### REPLACEMENT SYSTEM VARIANCE REQUEST

# SURFACE WASTEWATER DISPOSAL SYSTEM APPLICATION

SUBJECT: Approval, Replacement System Variance Request, Leino property, Augusta

2" EFFLOENT LINE (SEE PLAN) SUBSURFACE WASTEWATER DISPOSAL PLAN

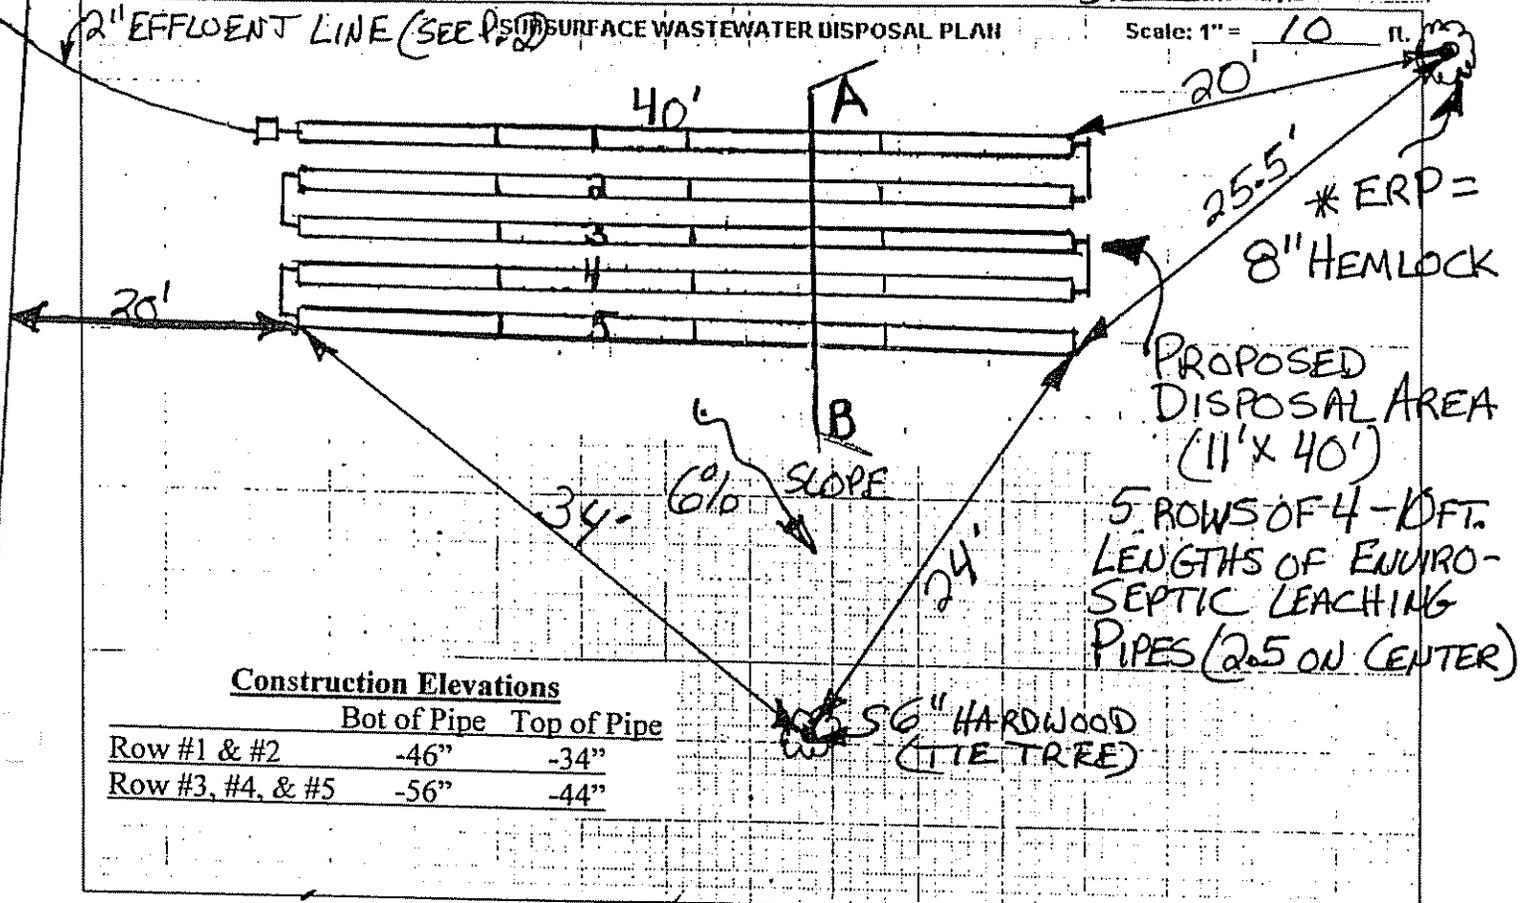
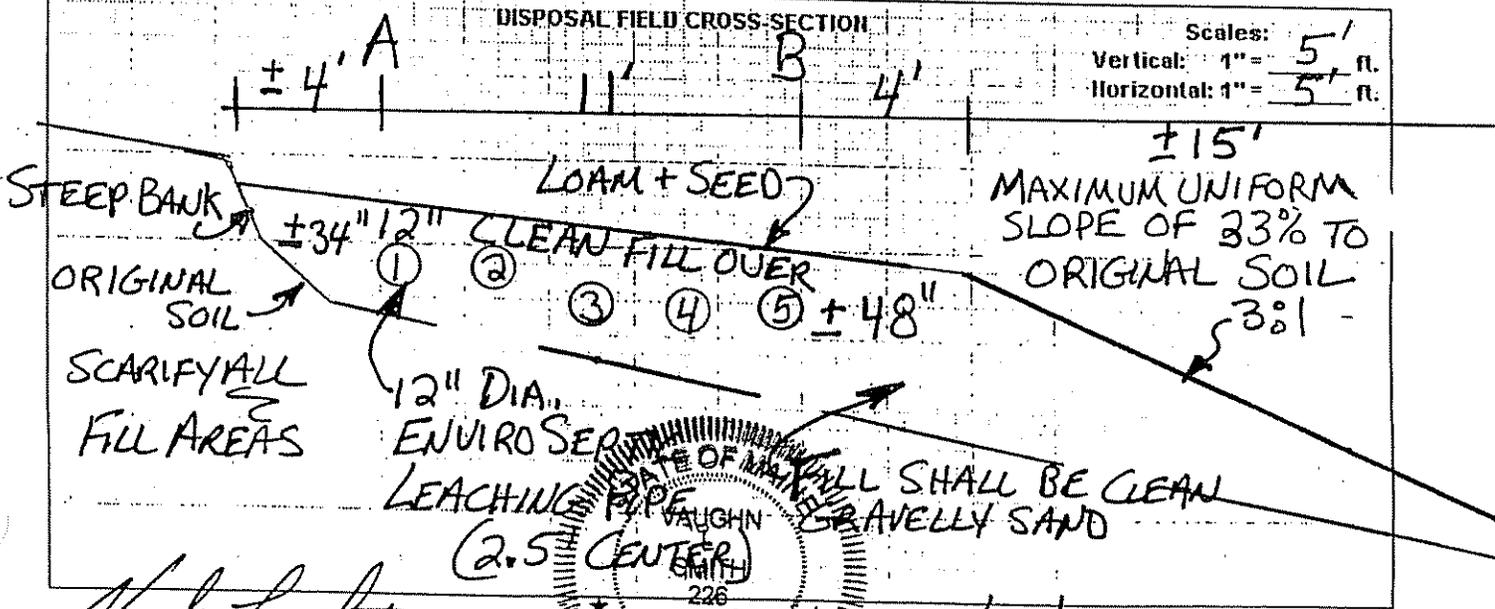
The Division has reviewed a replacement system variance request for the subject property. The state variance requested is to install the system with a setback distance reduction from your well to the septic tank of 35 feet, a setback distance reduction from a major watercourse to the disposal field of 50 feet and to the septic tank of 40 feet, a setback distance reduction from the edge of a fill extension to a special freshwater wetland, great pond, or stream to the disposal field of 30 feet, a reduction in depth to the seasonal high ground water table from 15 inches to 8 inches, and a fill extension grade to 3:1 as needed. As we understand the situation, the variance request has been submitted because topography and existing development limit the potential system location. The system design prepared by Vaughn Smith, SE, dated 05/20/2005 is otherwise found to be in compliance with the Maine Subsurface Wastewater Disposal Rules.

We approve the requested variance with the following requirements:

1. A permit for system installation is to be obtained from the Local Plumbing Inspector in advance of the start of system construction.
2. The system is to be installed in accordance with the submitted and approved system design. Should alterations to the design be required at the time of construction, the site evaluator is to be notified prior to making any changes.
3. The contractor is to scarify the soils under the fill extensions to create a transitional zone more compatible with the disposal field area.
4. If the existing septic tank(s) are to be used, they must be inspected thoroughly and found to be in good condition and meeting the requirements set forth in chapter 9 of the Subsurface Wastewater Disposal Rules. If not, they must be replaced with a monolithic tank.
5. The pump chamber shall be installed as far from the water as possible.
